PM4354

COMET-QUAD

**FOUR CHANNEL COMBINED E1/T1/J1
TRANSCEIVER/FRAMER**

Device Errata

3.2 External Analog Interface Circuit Diagram Missing Lines

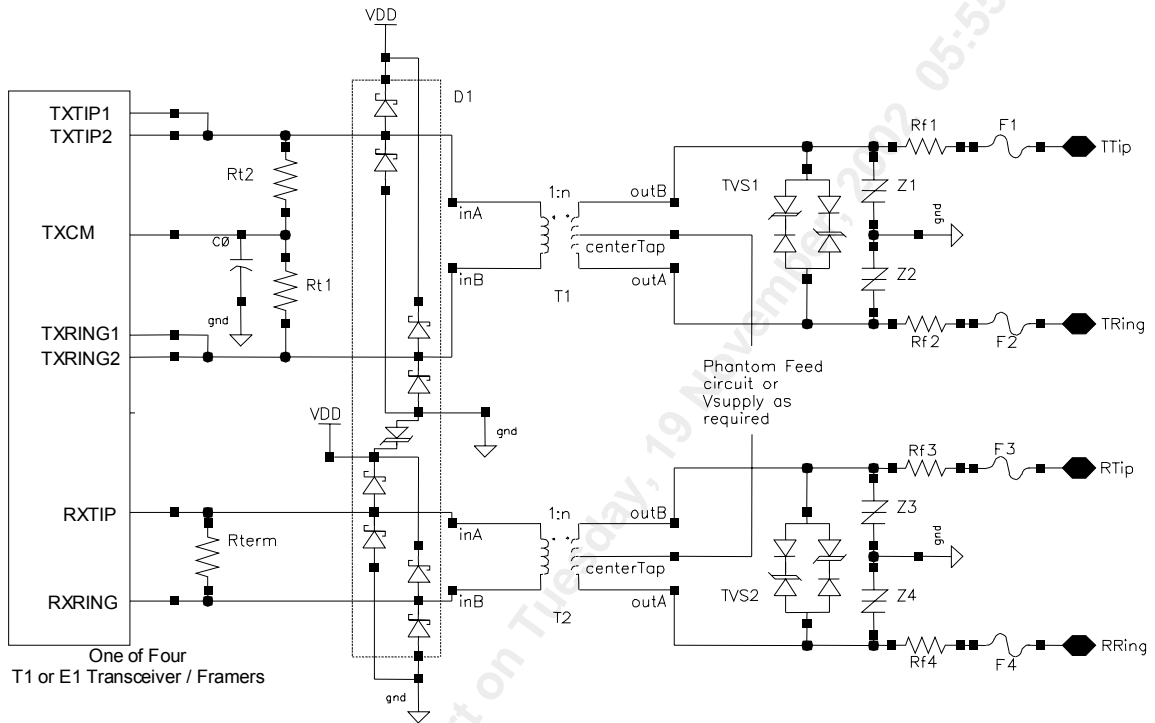
Figure 5 on page 34 of the COMET-QUAD Datasheet, “External Analog Interface Circuits,” is missing lines. The corrected version is shown below.

3.4 208 stPBGA Package

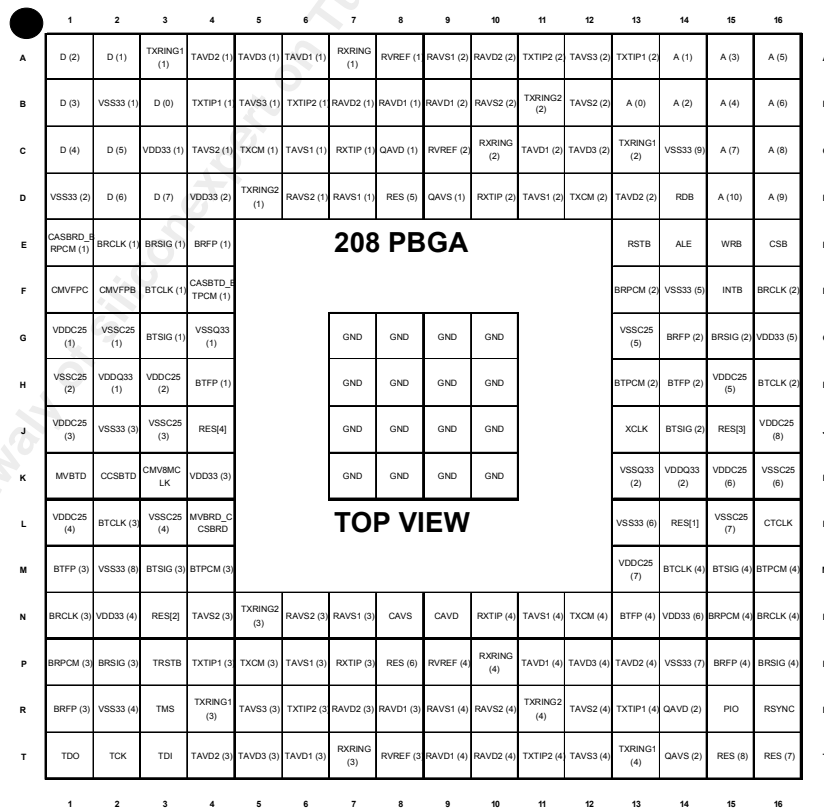
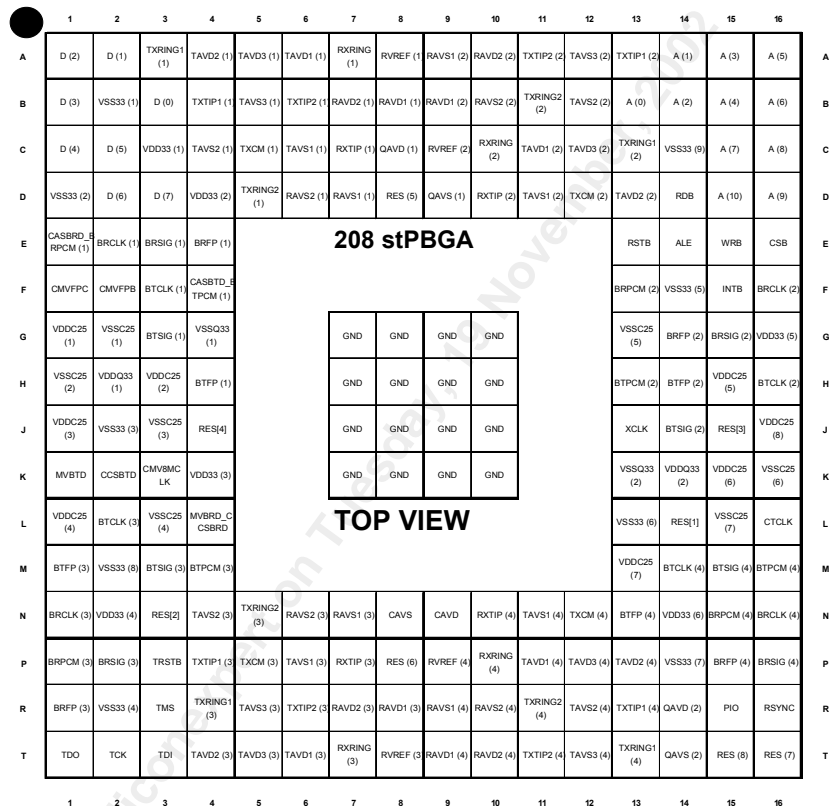
The COMET-QUAD package was changed to a 208-pin small thin Plastic Ball Grid Array (stPBGA).

- a) Reference to the old package on page 2 in Section 1 of the datasheet
- b) The Pin Diagram is on page 14 and 15 in Section 7 of the datasheet
- c) Table 110 is on page 445 in Section 18 of the datasheet
- d) The Mechanical Information is on page 446 in Section 19 of the datasheet

- a) Available in a high density 208-pin fine pitch stPBGA (17 mm by 17 mm) package
- b) The COMET-QUAD is packaged in a 208-pin stPBGA package having a body size of 17mm by 17mm and a ball pitch of 1.0 mm. The center 16 balls are not used as signal I/Os and are thermal balls.
